**HUBBARD PLANNING COMMISSION
STAFF REPORT**

DATE: September 15, 2022

FILE No.: **Bear Creek Planned Unit Development Subdivision #PUD 2022-01**

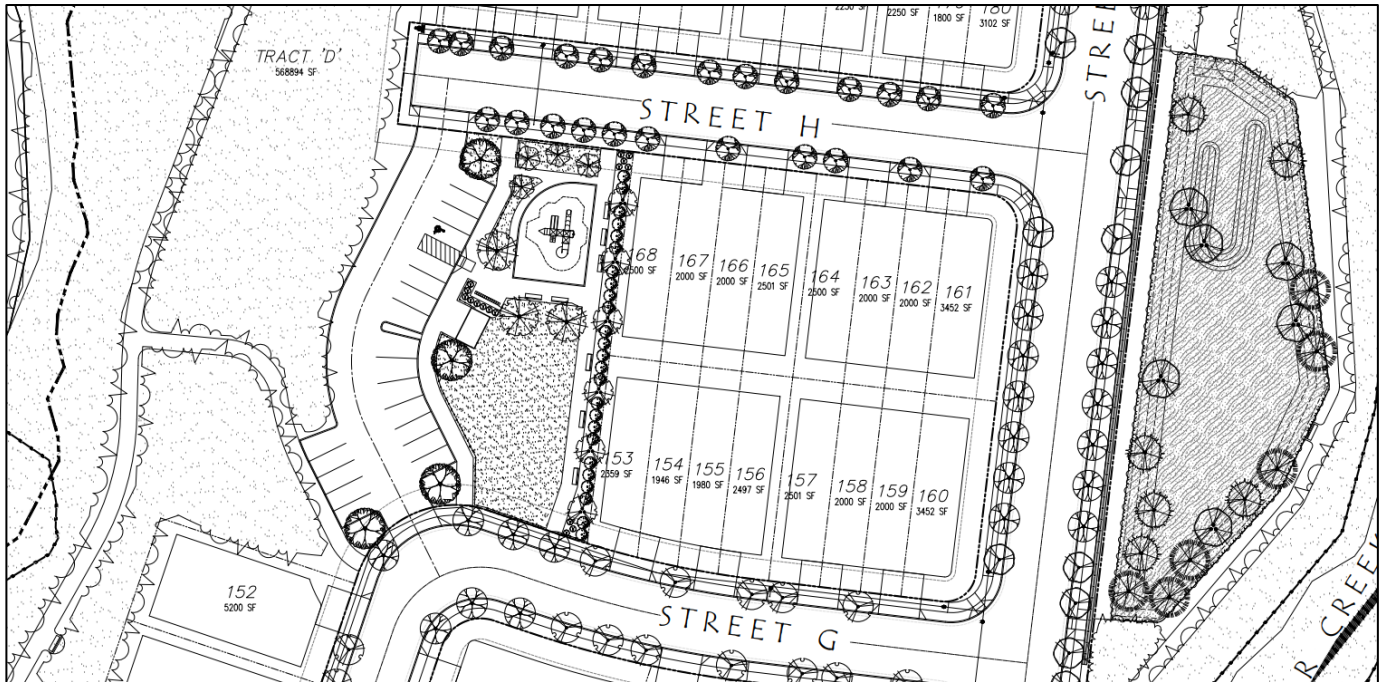
FINDINGS: The gross area of the subject property (excluding existing public rights-of-way adjacent to the project) is 54.42 acres, or 2,370,535.20 SF. Twenty percent of 2,370,535.20 SF is 474,107.04 SF. This figure is slightly higher than the applicant calculated above using the Net Site Area (NSA) rather than the gross area, but still well below the proposed total open space area of 879,247 SF (20.18 acres). The proposed amount of open space area exceeds the minimum 20% required. While not all portions of open space Tracts D and E will be usable by the neighborhood residents and public due to stormwater basins, steep slopes, wetlands, and dense riparian vegetation, the environmental benefits to water quality, flood mitigation, and habitat continuity are valuable to the City of Hubbard, and greater region. Staff notes that there are a total of four storm water basins with Tracts D and E, and those are included in the applicant's open space calculation, but Tract A, which is purely a stormwater basin on the south end of the PUD is not included in the open space. The applicant states that if the stormwater basin areas are subtracted from open space Tracts D and E, the adjusted sizes are 436,603 SF and 281,797 SF respectively. With that adjustment, the two open space tracts total 718,400, which is approximately 30%, still well above the minimum 20% standard.

Tract D contains the Mills Creek riparian corridor, wetlands, stormwater basins with access roads for maintenance, 8-foot wide gravel walking path with multiple connections, a park with play structure and play field, public restroom, vehicle parking, and benches. Below is a cropped image showing the proposed public park with public parking, play structure, restrooms, and play field.

SCREENSHOTS INCLUDED BELOW OF PUD FOR REFERENCE IN PARKING DISCUSSION

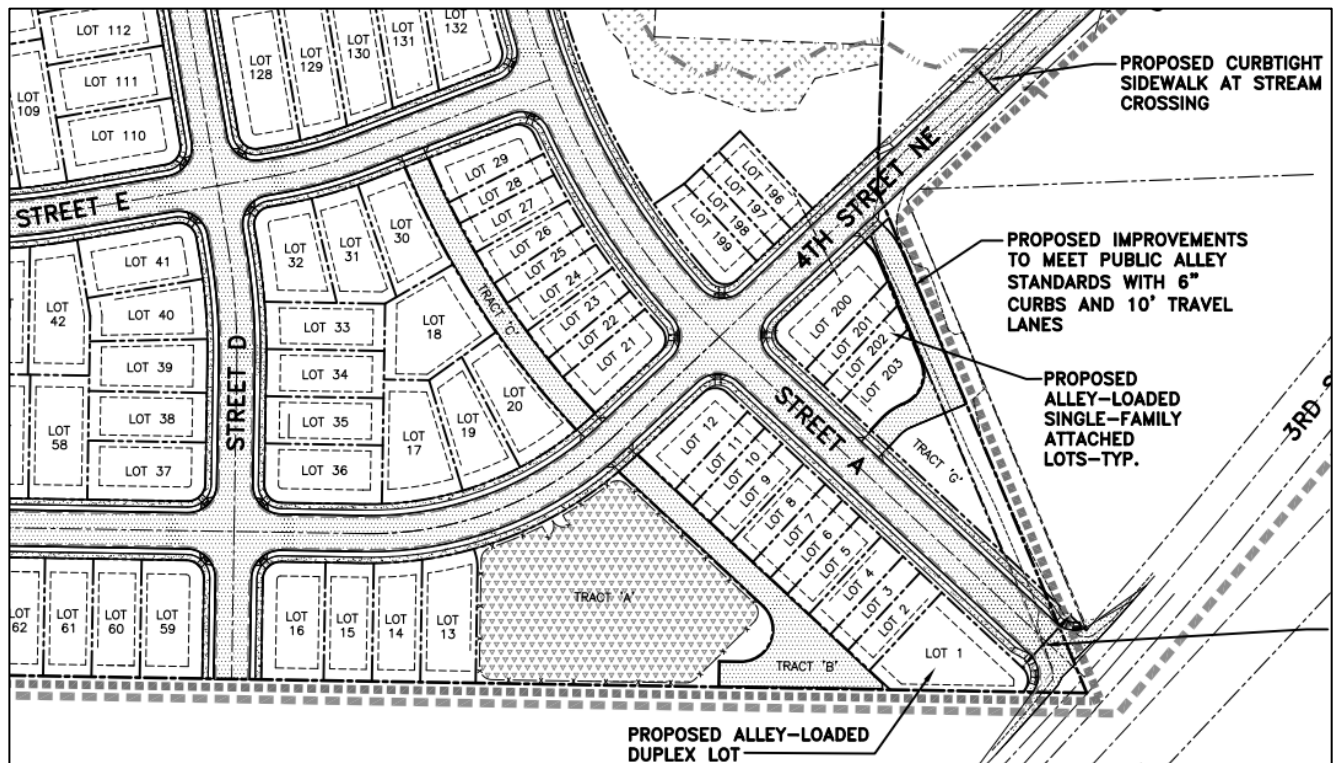
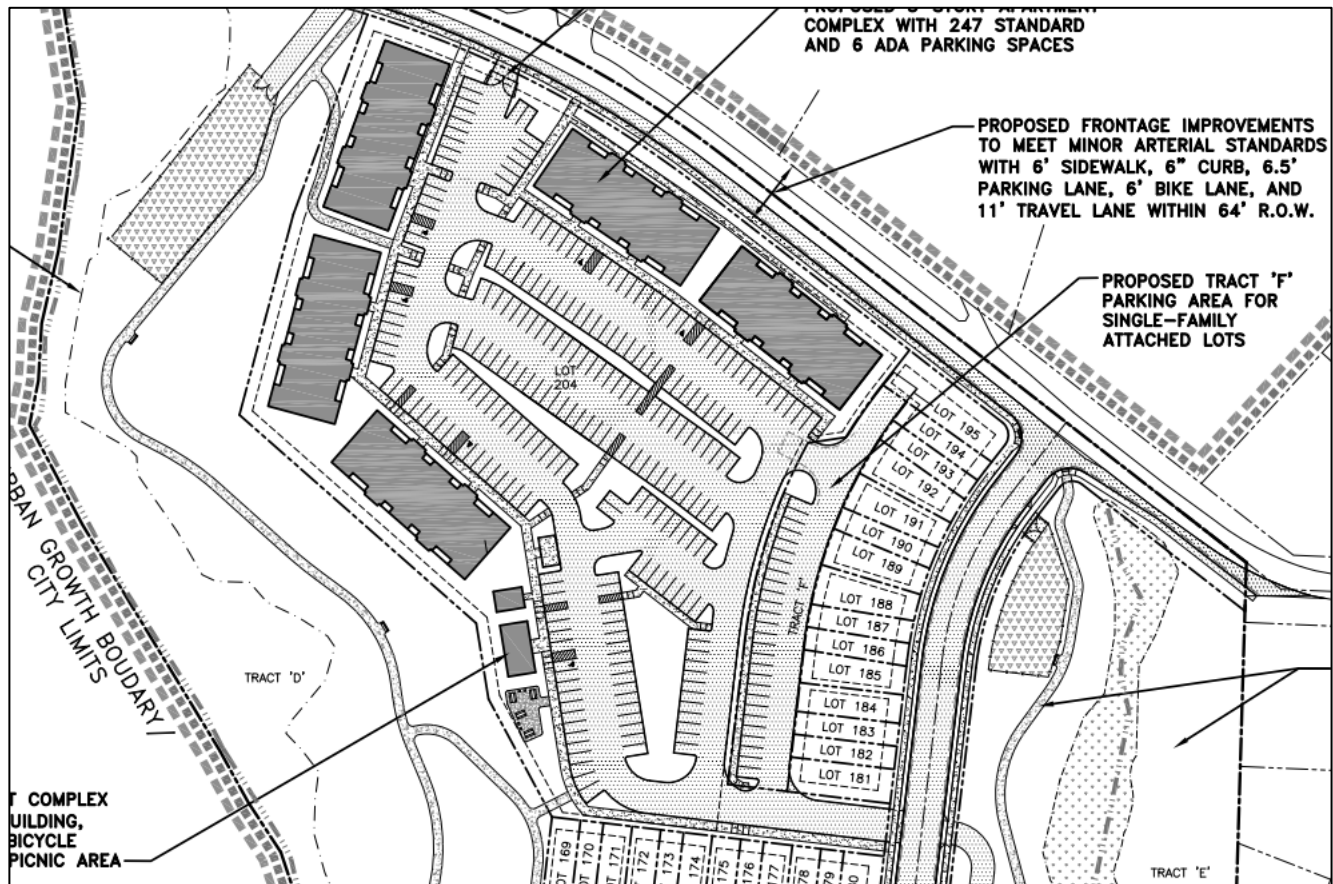
FINDINGS: HDC 2.203.05 Off-Street Automobile Parking Requirements requires one and two-family (duplex) dwellings to provide two off-street parking spaces. These are typically provided as one in the garage and one in the driveway. Multi-family dwellings (apartments) are also required to provide two spaces per dwelling unit. The application materials state that all types of dwelling units are proposed to provide two spaces. There are also parking spaces available on the streets fronting many of the dwelling units. All of the townhouse lots along Street A are alley-loaded with the garage and driveway in the rear, and street parking out front. Additionally, the applicant has provided an additional row of overflow parking in Tract F to serve the northern row of townhomes, Lots 181 – 195. This may also end up serving as overflow for the multi-family development. Out of concern for parking congestion in other parts of the city causing issues with emergency response and garbage collection, City staff recommend that the developer also provide additional overflow parking to serve the southern rows of townhouses, potentially in the location of proposed Lot 120.

Regarding parking for the proposed park in Tract D, HDC 2.203.05(T) *Outdoor and other uses. Other uses not specially listed above shall furnish parking as required by the Planning Commission. The Commission shall use the above list as a guide for determining requirements for said other uses.* There is no minimum parking ratio standard for a public park. The proposed 20 spaces, including one ADA space, may be sufficient.
